| Well Name: STRANGER 34 FED COM | Well Location: T25S / R34E / SEC 34 / SESE / 32.0802855 / -103.4509461 | County or Parish/State: LEA / NM |

Notice of Intent

Type of Action: APD Change

Procedure Description: Devon Energy Production Company, L.P. respectfully requests approval for optional surface casing/drilling plan of 10-3/4" surface casing inside of 13-1/2" surface hole at previously permitted set depths. Devon Energy Production Company, L.P. will circulate class C cement to surface behind the 10-3/4" casing. Please see the attached plans. Devon is also requesting a break test variance. The variance request and chart is attached.

Variance Request

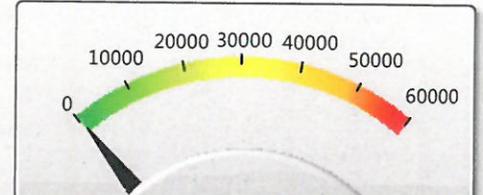
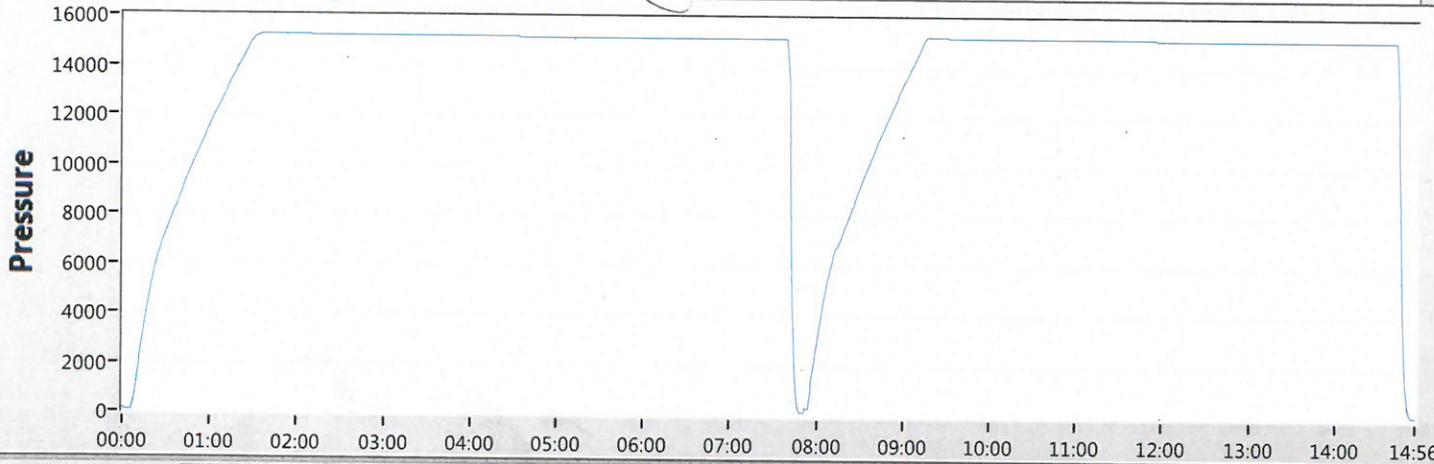
Devon Energy requests to only test BOP connection breaks after drilling out of surface casing and while skidding between wells which conforms to API Standard 53 and industry standards. This test will include the Top Pipe Rams, HCR, Kill Line Check Valve, QDC (quick disconnect to wellhead) and Shell of the 10M BOPE to 5M for 10 minutes. If a break to the flex hose that runs to the choke manifold is required due to repositioning from a skid, the HCR will remain open during the shell test to include that additional break. The variance only pertains to intermediate hole-sections and no deeper than the Bone Springs Formation where 5M BOP tests are required. The initial BOP test will follow OOGO2.III.A.2.i, and subsequent tests following a skid will only test connections that are broken. The annular preventer will be tested to 100% working pressure. This variance will meet or exceed OOGO2.III.A.2.i per the following: Devon Energy will perform a full BOP test per OOGO2.III.A.2.i before drilling out of the intermediate casing string(s) and starting the production hole, before starting any hole section that requires a 10M test, before the expiration of the allotted 14-days for 5M intermediate batch drilling or when the drilling rig is fully mobilized to a new well pad, whichever is sooner. We will utilize a 200' TVD tolerance between intermediate shoes as the cutoff for a full BOP test. The BLM will be contacted 4hrs prior to a BOPE test. The BLM will be notified if and when a well control event is encountered. Break test will be a 14 day interval and not a 30 day full BOPE test interval. If in the event break testing is not utilized, then a full BOPE test would be conducted.

1. Well Control Response:
 1. Primary barrier remains fluid
 2. In the event of an influx due to being underbalanced and after a realized gain or flow, the order of closing BOPE is as follows:
 - a) Annular first
 - b) If annular were to not hold, Upper pipe rams second (which were tested on the skid BOP test)
 - c) If the Upper Pipe Rams were to not hold, Lower Pipe Rams would be third

BOPE Break Testing Variance

- BOPE Break Testing is ONLY permitted for 5M BOPE or less. **(Annular preventer must be tested to a minimum of 70% of BOPE working pressure and shall be higher than the MASP)**

- BOPE Break Testing is NOT permitted to drilling the production hole section.
- Variance only pertains to the intermediate hole-sections and no deeper than the Bone Springs formation.

- While in transfer between wells, the BOPE shall be secured by the hydraulic carrier or cradle.
- Any well control event while drilling require notification to the BLM Petroleum Engineer **(575-706-2779)** prior to the commencement of any BOPE Break Testing operations.

- A full BOPE test is required prior to drilling the first deep intermediate hole section. If any subsequent hole interval is deeper than the first, a full BOPE test will be required. (200' TVD tolerance between intermediate shoes is allowable).

- The BLM is to be contacted **(575-689-5981 Lea County)** 4 hours prior to BOPE tests.
- As a minimum, a full BOPE test shall be performed at **14-day** intervals.

- In the event any repairs or replacement of the BOPE is required, the BOPE shall test as per Onshore Oil and Gas Order No. 2.
- If in the event break testing is not utilized, then a full BOPE test would be conducted.
